**EXHIBIT**  
**Waterblasting -2002**

APPLICATION NUMBER	FILING OR 371(C) DATE	FIRST NAMED APPLICANT	ATTY. DOCKET NO./TITLE
10/884,643	07/02/2004	James P. Crocker	2708U.001

<b>PATENT - POWER OF ATTORNEY OR REVOCATION OF POWER OF ATTORNEY WITH A NEW POWER OF ATTORNEY AND CHANGE OF CORRESPONDENCE ADDRESS</b>	Patent Number	7,255,116
	Issue Date	August 14, 2007
	First Named Inventor	James P. Crocker
	Title	STRIPE REMOVAL SYSTEM
	Attorney Docket Number	2708U.001

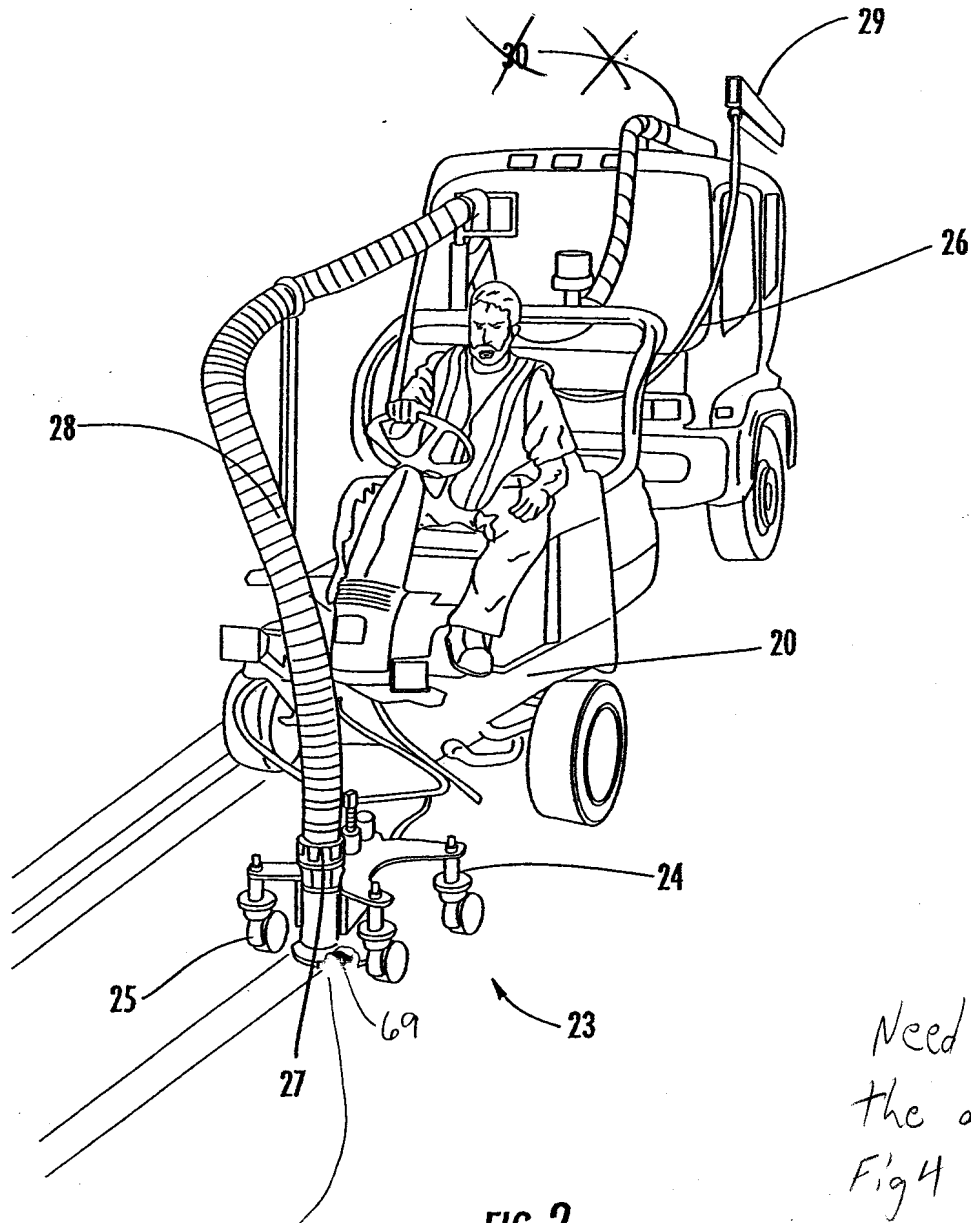
The leader should extend to the bed of the truck

Section here  
to add spray  
bar & nozzle

In amended Figure 1, the previously duplicate element numeral 12 has been changed to 17 in addition element numeral 67 has been substituted for element numeral 12 in the specification and figures when referring to the pump to eliminate the duplication of element numerals.

In amended Figure 1, the previously duplicate element numeral 12 has been changed to 17 in addition omitted element numeral 67 has been added.

FIG. 3

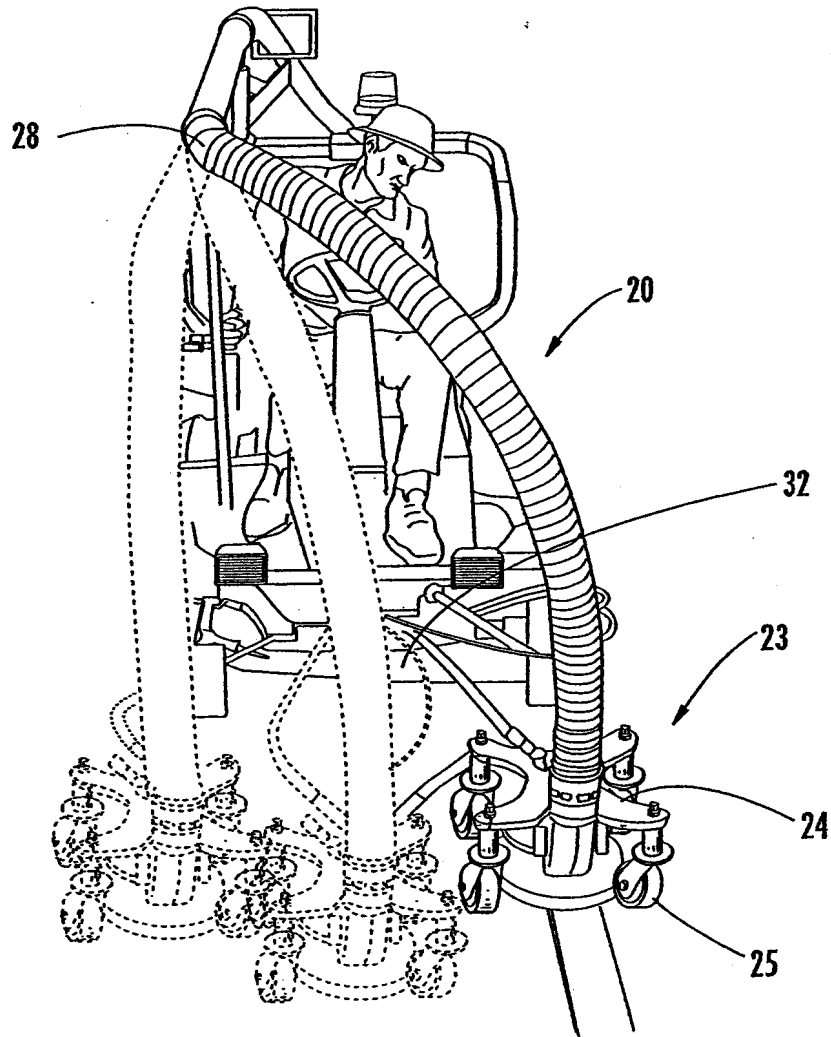
Add in the  
arm

In amended Figure 3, the arm of Figs. 4 and 5 has been added for clarity.

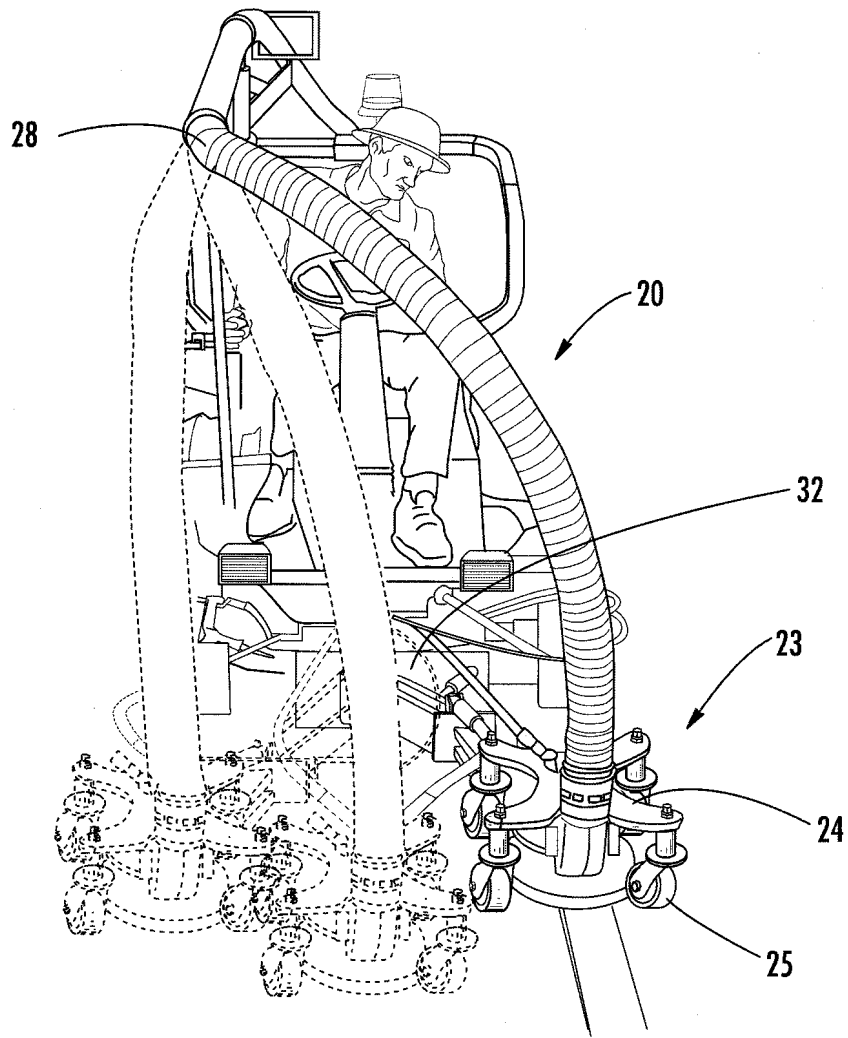
- 1) Fig. 3 is described in the specification as showing the blast head connected to the tractor by an articulated link 31. The link is not shown in Fig. 3;
- 2) Fig. 4 does not show items 42' and 40' which are described in the specification;
- 3) Item 30 (Fig. 2) is not described in the specification;
- 4) Fig. 6, Items 28 and 66 appear to be reversed. The vacuum hose 28 is shown as being connected to the outlet (58) and this appears to be a reversal of what is described in the specification (page 12, ll. 16-18);
- 5) Item 70 in the specification is not shown in the drawings.

**FIG. 7**

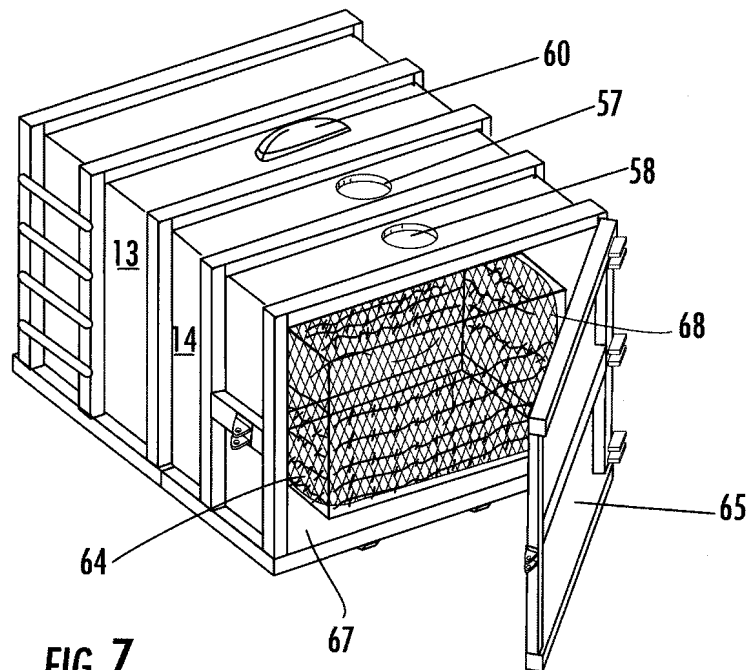
The drawings are objected to under 37 CFR 1.83(a). The drawings must show every feature of the invention specified in the claims. Therefore, the nozzle and filter bag must be shown or the feature(s) canceled from the claim(s). No new matter should be entered.

In amended Figure 7, element numeral 68 has been added to reference the filter bag. Support for adding the filter bag element numeral can be found throughout the specification. For example at page 13, line 10; "An additional filter bag with having between 5-200 micron porosity may be inserted into the enclosure. The dimensions of the enclosure 64 are somewhat less than the interior of the sump which provides a marginal area 65 between the enclosure and the interior walls and floor of the sump which provides an exit path for filtered water through valve 70".

In amended Figure 7, element numeral 68 has been added to reference the filter bag.

FIG. 1

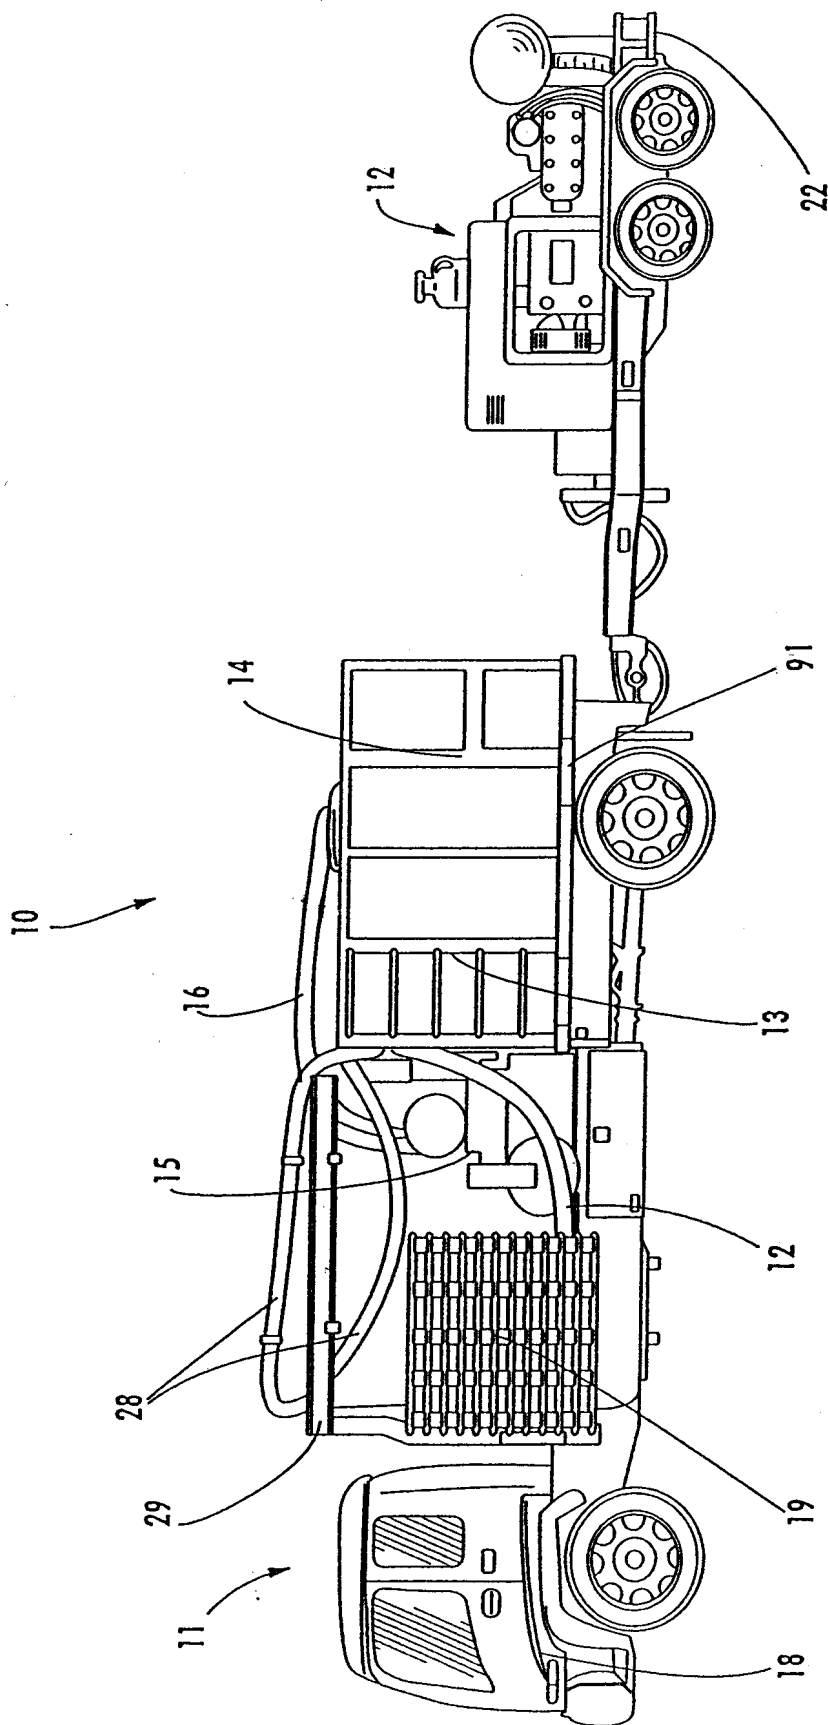
The drawings are objected to as failing to comply with 37 CFR 1.84(p)(4) because reference characters "19" and "28" have each been used to designate two different items in Figure 1. Corrected drawing sheets in compliance with 37 CFR 1.121(d) are required in reply to the Office action to avoid abandonment of the application. Any amended replacement drawing sheet should include all of the figures appearing on the immediate prior version of the sheet, even if only one figure is being amended. Each drawing sheet submitted after the filing date of an application must be labeled in the top margin as either "Replacement Sheet" or "New Sheet" pursuant to 37 CFR 1.121(d). If the changes are not

The drawings stand objected to under 37 CFR 1.184(p)(4) because reference characters "19" and "28" have each been used to designate two different items in Figure 1. Figure 1 has been amended to change "19" referring to the rear portion of the tank to "91" to avoid the double inclusion. Reference "28" referring to the upper portion of the tank has been eliminated from the first Figure to avoid the double inclusion. New drawings are being submitted herewith for approval by the Examiner.

The drawings stand objected to under 37 CFR 1.184(p)(4) because reference characters "19" and "28" have each been used to designate two different items in Figure 1. Figure 1 has been amended to change "19" referring to the rear portion of the tank to "91" to avoid the double inclusion. Reference "28" referring to the upper portion of the tank has been eliminated from the first Figure to avoid the double inclusion. New drawings are being submitted herewith for approval by the Examiner.

**FIG. 6**

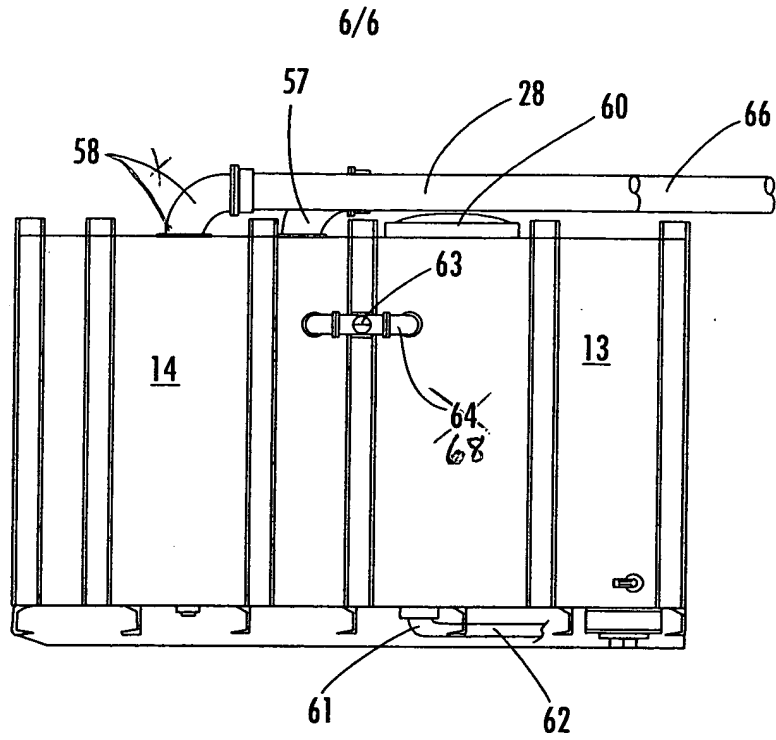
The drawings are objected to as failing to comply with 37 CFR 1.84(p)(4) because reference characters "58" (Fig. 6 & 7), "39" (Fig. 4), and "65" (Fig. 7) have been used to designate two items. Corrected drawing sheets in compliance with 37 CFR 1.121(d) are required in reply to the Office action to avoid abandonment of the application. Any amended replacement drawing sheet should include all of the figures appearing on the

Fig. 6 has been amended to correct the problem with reference character "58".

Fig. 6 has been amended to change reference character 64 (connector pipe) to reference character 68 to avoid the double inclusion.
